SERVICE BULLETIN ML 0004

Date : Friday, February 19, 1999
Game : Ripper Ribbit
Subject : Power fused on neutral line

Problem : Power Distribution Box fused on neutral line

Figure 1 Before

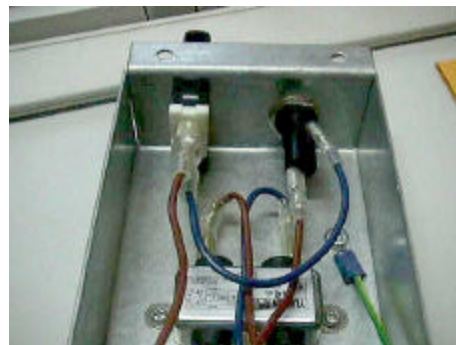
Solution : Remove DB box from machine and inspect for fuse in neutral line (See Figure 1). If this is the case follow the instructions listed below.

1. Remove Blue wire line-in on Noise Filter (going to fuse holder) and connect it to lower pole of Power Switch.
2. Take the Brown wire that you removed from the lower switch pole and cut of 6.8mm Quick Connect terminal. (Saving Plastic Insulating sleeve for step 5)
3. Remove the other Blue wire from Fuse holder coming from Power input socket and cut off 5mm Quick Connect terminal. (Saving Plastic Insulating sleeve for step 4)
4. Crimp to the brown wire in step 2 a new 5mm Quick Connect terminal and connect to fuse holder.
5. Crimp to the Blue from the Power input socket a new 6.8mm Quick Connect terminal and connect to the Line-in on the Noise Filter
6. Inspect that all new Joints are correct (See Figure 2) and reinstall DB box into machine
